SUPPLEMENTAL SITE CERTIFICATION APPLICATION

ORLANDO UTILITIES COMMISSION CURTIS H. STANTON ENERGY CENTER UNIT B IGCC PROJECT RECEIVED

MAY 08 2006
SUFFICIENCY RESPONSES

**SUPPLEMENTAL SITE CERTIFICATION APPLICATION
SUFFICIENCY RESPONSE**

Figure 6-2
Effect of Coal Quality on Heat Rate and Capital Cost

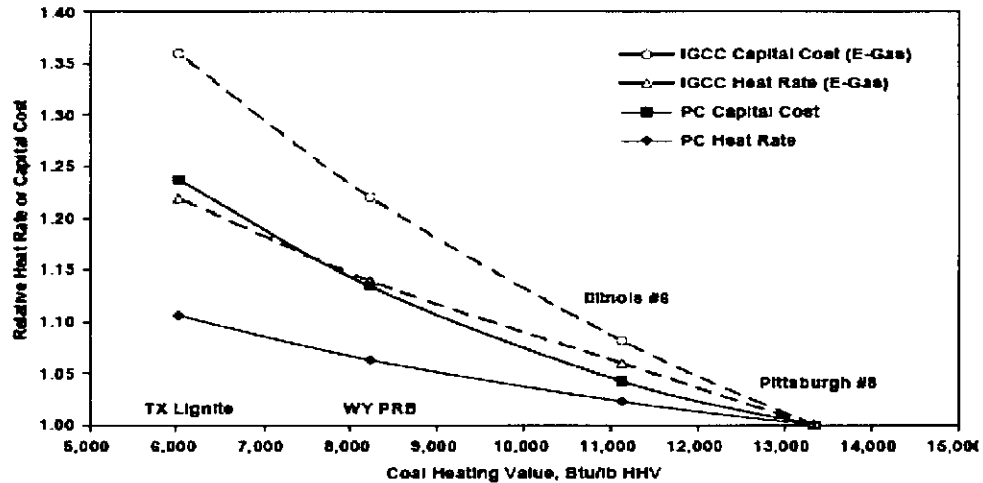
FDEP-2—According to available information, the pilot-scale KBR Transport Gasifier was tested at Wilsonville for air-blown and for oxygen-blown configurations. According to the SCA, an air-blown design will be demonstrated. Please provide the justification for selection of the air-blown variant and its impacts on emissions and emission control options. Include any information related to requirement, if any, for an air-blown version versus an oxygen-blown version to receive the DOE support. In the air-blown variations, the coal is introduced into the gasifier with compressed air. In the oxygen-blown variations, an air separation unit (ASU) is necessary to separate at-

Stanton Unit B will utilize a sub-bituminous Powder River Basin (PRB) coal—a low-rank, high-moisture, high-ash coal. Because low-rank, high-moisture, and high-ash coals comprise approximately half the proven coal reserves in the United States and the world, utilization of these coals for power generation is an essential component of United States energy policy. Currently employed integrated gasification combined-cycle (IGCC) technologies use high-rank fuels and are not competitive economically for operation with low-rank fuels. A recent Electric Power Research Institute (EPRI) report discussed the effect of coal quality on coal plant economic feasibility and published the figure below showing the impact of coal rank on the relative heat rates and capital cost of pulverized coal (PC) plants and IGCC plants. The report stated, "This illustrates the widening gap for lower rank coals, particularly for slurry-fed gasifiers, such as ChevronTexaco (now

owned by GE) or ConocoPhillips. This reinforces the need for development of improved gasifiers, such as the KBR Transport Gasifier, for low-rank coals.”

Although some proposed future IGCC plants include the technical flexibility to process sub-bituminous coals, economic estimates using these technologies with sub-bituminous coal compare unfavorably to bituminous coal. While all gasifiers can process low-rank sub-bituminous coals, not all gasifiers can perform as well economically as the air-blown Transport Gasifier. Economic studies performed by EPRI and by SCS in conjunction with DOE, indicate that the Transport Gasifier is an economically promising option.

Effect of Ammonium Bisulfate Formation on Plant Availability

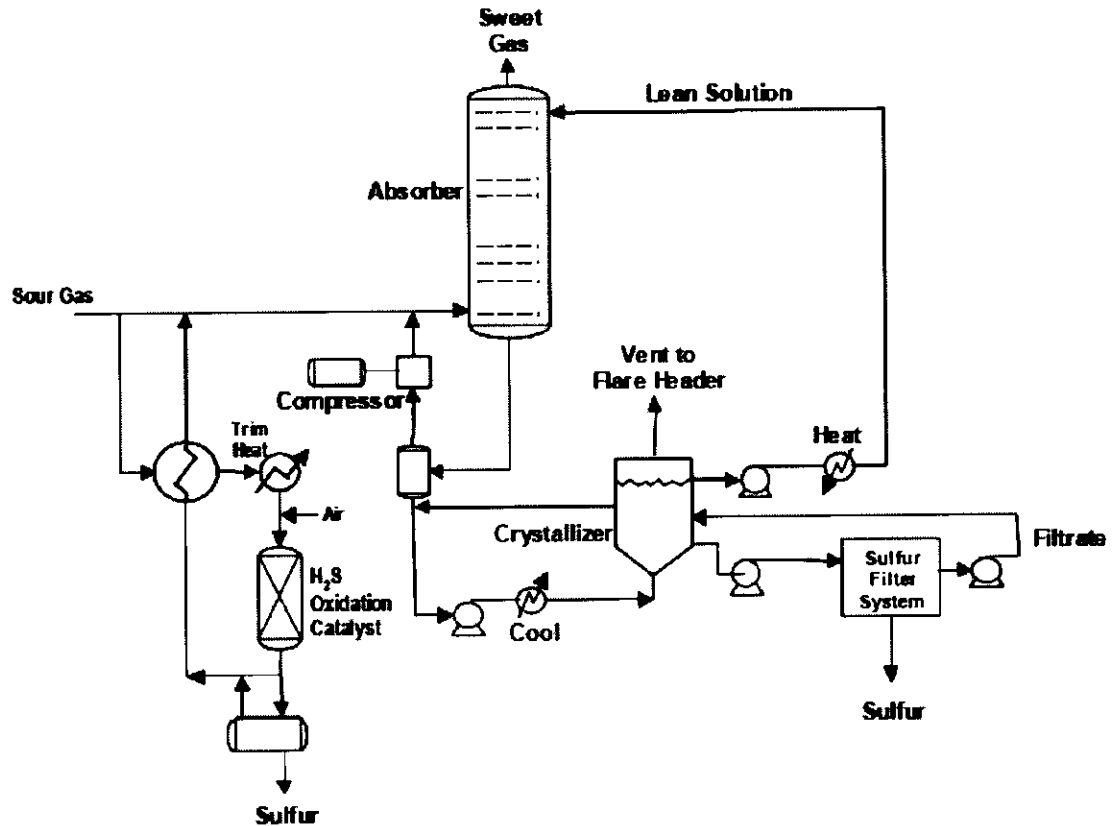
FDEP-12—Please provide an estimate on the breakpoint when sulfur in the syngas actually becomes a problem. On the one hand, the claim is made that virtually any sulfur presents a problem. On the other hand, GE seems to believe that 0.01 lb SO₂/mmBtu is acceptable for its oxygen-blown gasifier design while achieving very low NO_x emissions. Note that with the great head-start from low sulfur PRB coal this issue will not be as difficult as it is for high sulfur Eastern coal IGCC plants for which GE developed.

Any amount of sulfur in the CT exhaust gas creates the potential for ammonium salt formation and deposition and/or acid corrosion in the heat recovery steam generator (HRSG). Problems such as these that lead to lower reliability, forced outages, or increased maintenance outages are unacceptable for a planned base-loaded unit such as Stanton Unit B. Even at the low levels that have been proposed for Stanton Unit B, sulfur

A study performed by GE and presented by EPRI predicted the effects of ammonium bisulfate (ABS) formation on plant forced outage rates. The chart below shows the predicted forced outages caused by ABS as a function of SO_x concentration in the turbine exhaust gas. It is important to note that the chart reflects only 5-percent oxidation of SO₂ to sulfur trioxide (SO₃), which is an expected reaction in the CT. Therefore, the assumed SO_x concentration only contains 5 percent SO₃, the precursor to ammonium salts and acid gas. (Wabash River Generating Plant has reported 9-percent oxidation of SO₂.)

However, further oxidation of SO₂, which would be expected if an oxidation catalyst is used, would significantly exacerbate the problem of acid gas and ABS formation. The scale at the top of the chart shows the calculated SO₃ concentration based on 5-percent oxidation. If using an oxidation catalyst, 50- to 90-percent oxidation of SO₂ would be expected based on vendor information and EPRI reports. Based on the GE study, for a syngas sulfur concentration at the lowest theoretically achievable value, 50-percent oxidation could potentially cause seven unplanned shutdowns per year.
